UNITED STATES PATENT AND TRADEMARK OFFICE

APPLICATION NO.	FILING DATE	FIRST NAMED INVENTOR	ATTORNEY DOCKET NO.	CONFIRMATION NO.
10/033,883	12/27/2001	Wen-Fa Yao	JCLA3573	9398

Office Action Summary	Application No. 10/033,883	Applicant(s) YAO ET AL.	
	Examiner Roy M. Punnoose	Art Unit 2877

DETAILED ACTION

Figure 9 of the Klein Patent (US_4,554,460) is shown above.

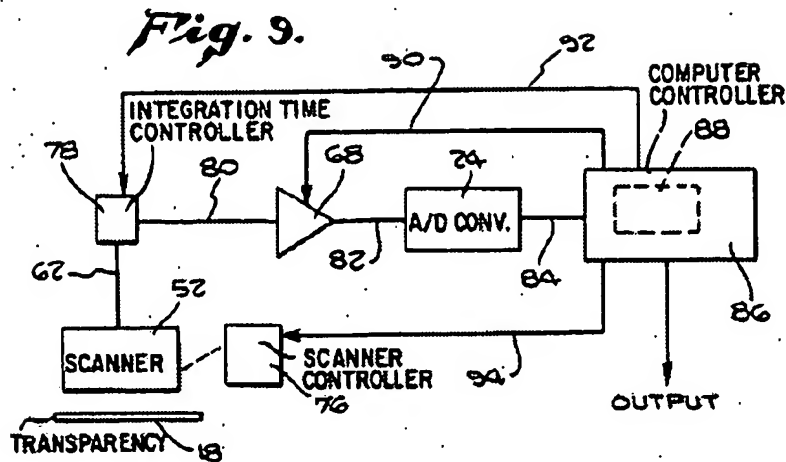
Klein discloses a scanning analyzer unit comprising:

A). A scanning processor unit 52 that scans the testing support 18, wherein the scanning processor unit 52 outputs a test signal 62 resulting from the scan of the testing support 18 (see Figure 9);

a signal amplifier 68 that is coupled with the scanning processor unit 52 to amplify the test signal 62, 80;

an analog/digital converter 24 that is coupled with the signal amplifier 68 and the computing unit 86, wherein the analog/digital converter 24 converts the amplified test signal 82 into a digital signal 84 that is transferred to the computing unit 86;

a computing unit 86 (see col.5, line 21) that is coupled with the scanning processor unit 52, wherein the computing unit 86 receives and analyzes the test signal 62;

a controller device 86 that is coupled with the scanning processor unit 52, wherein the controller device 86 outputs a driver signal 94; and,

a driver device 76 that is coupled with the controller device 86 and the scanning processor unit 52, wherein the driver device 76 receives the driver signal and accordingly drives the scanning processor unit 52 to accomplish the scan of the testing support 18 (see col. 5, lines 10-30), the scanning analyzer used for analyzing testing results that are obtained from a testing support for determining spectral quality of a sample under test (see col. 1, lines 6-31).

However, Klein does not teach of a scanning analyzer apparatus comprising separate computing unit and controller device for analyzing the test signal from the scanning processor unit and controlling a driver device based on the scanning processor unit output, the scanning analyzer apparatus used for analyzing testing results that are obtained from a testing support for determining spectral quality of a sample under test.

B). Klein teaches of a scanning analyzer apparatus comprising a combined computing unit and controller device 86 for analyzing the test signal from the scanning processor unit 52 and controlling a driver device 76 based on the scanning processor unit output 62 (see Figure 9; see col. 5, lines 10-30), the scanning analyzer apparatus used for analyzing testing results that are obtained from a testing support for determining spectral quality of a sample under test.

C). In view of Klein's teaching, it would have been obvious to one of ordinary skill in the art at the time the invention was made to modify Klein's apparatus by having a separate computing unit and a controller device due to the fact that such separate computing and controlling units would provide a modular system where each module can easily be replaced for repair and/or maintenance of the scanning analyzer apparatus, used for analyzing testing results that are
